## Comments on the Informal document GRSP-69-18

Part 1: Comments on the document GRSP-69-18 and

Part 2: Comments on the document ECE/TRANS/WP.29/GRSP/2021/15

#### Proposal of Supplement 2 to the 06 series of amendments to UN Regulation No. 22 (Protective helmets)

*Annex 8 - New figure 1d, amend to read:*

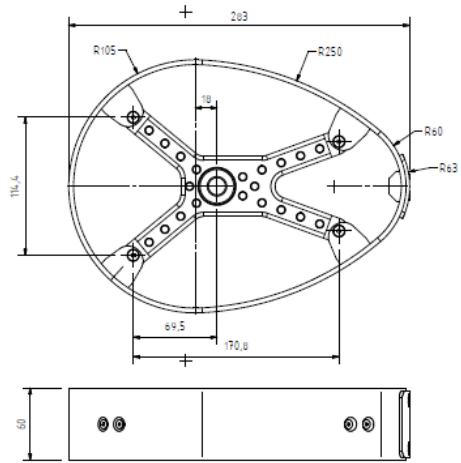
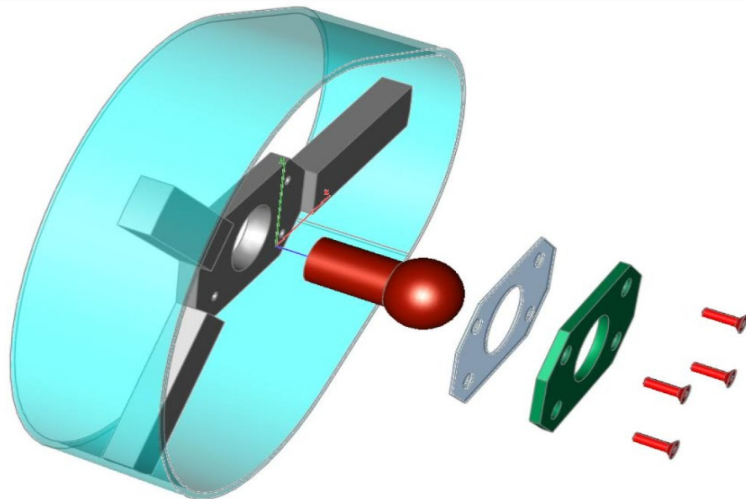
**Comment:** This simulator does not reproduce the actual behaviour that the accessory would have if fitted to a helmet. The helmet can rotate around the headform during the test . This simulator only gives one degree of freedom: rotation through the fixation axe

New simulator proposal with three degrees of freedom could better represent what could happen in a real test.

The new proposed system could be calibrated as it is the Hybrid III femur-hip joint.

Figure 1

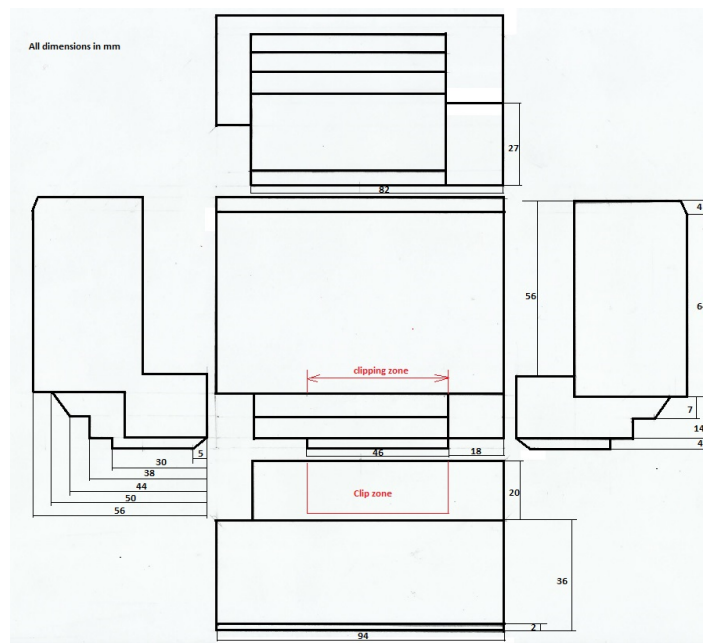
Comment: [Volume was only indicated in the document as a reference for defining the building possibilities, no need to introduce it in the text]

Figure 2

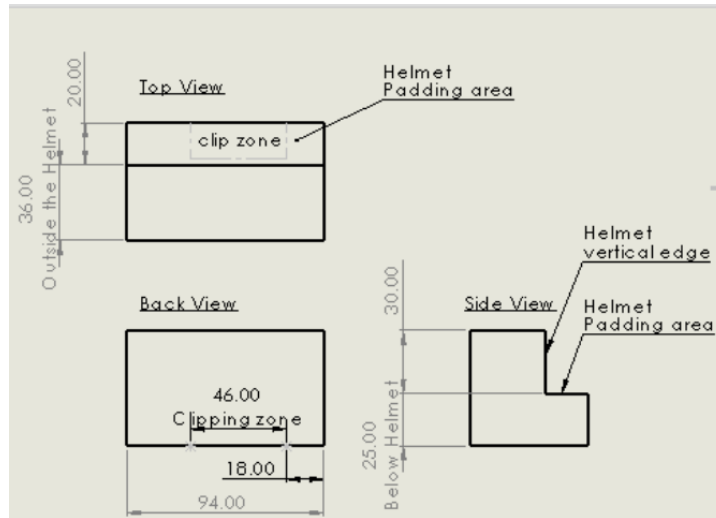
Comment: [Volume was only indicated in the document as a reference for defining the building possibilities, no need to introduce it in the text]

Figure 3

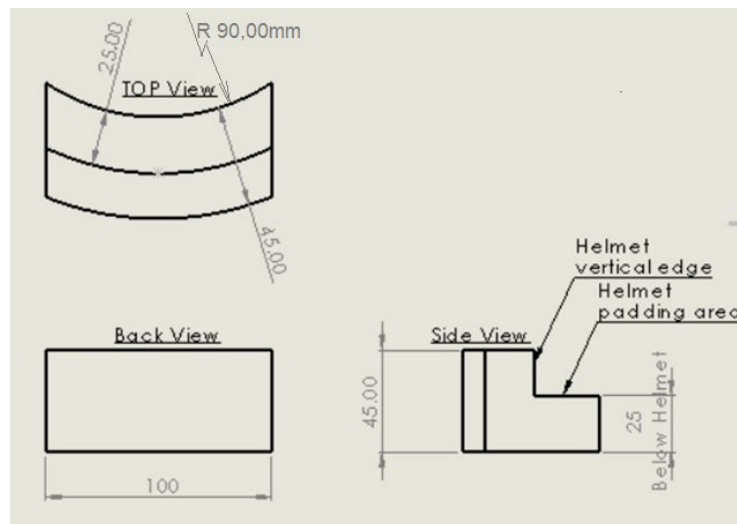
Comment: [Volume was only indicated in the document as a reference for defining the building possibilities, no need to introduce it in the text]

### 3.2 Criteria

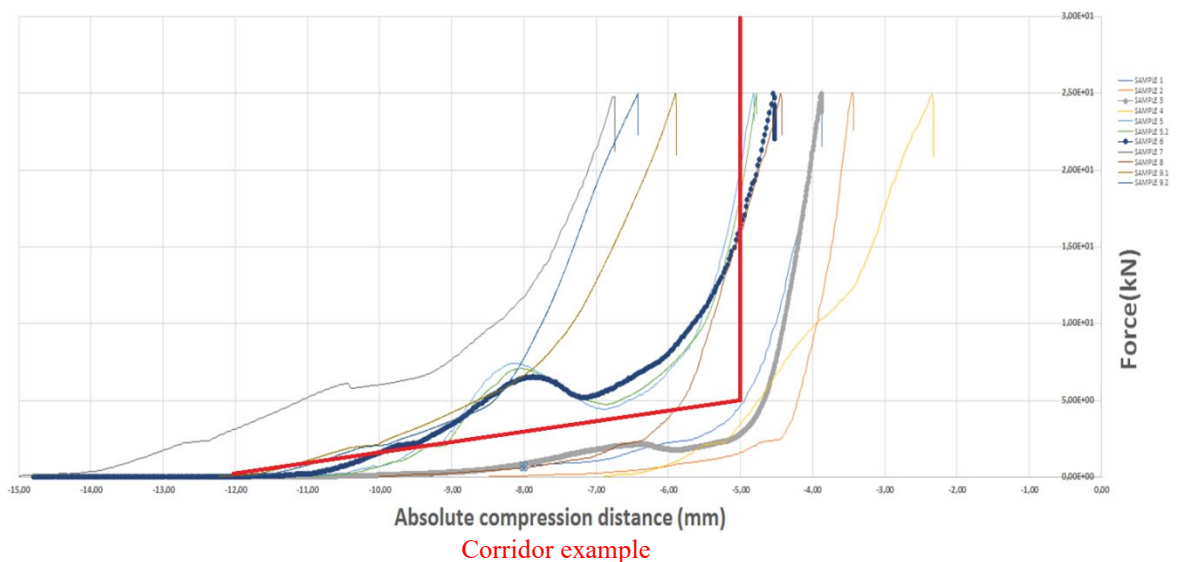
**Comment:** More tests are necessary. Industry does not have any clear input on the impact this might have on the helmet results. Only one or two helmets reported to be tested and no data from the conditions or geometry of the pockets or EPS or shell or even size tested.
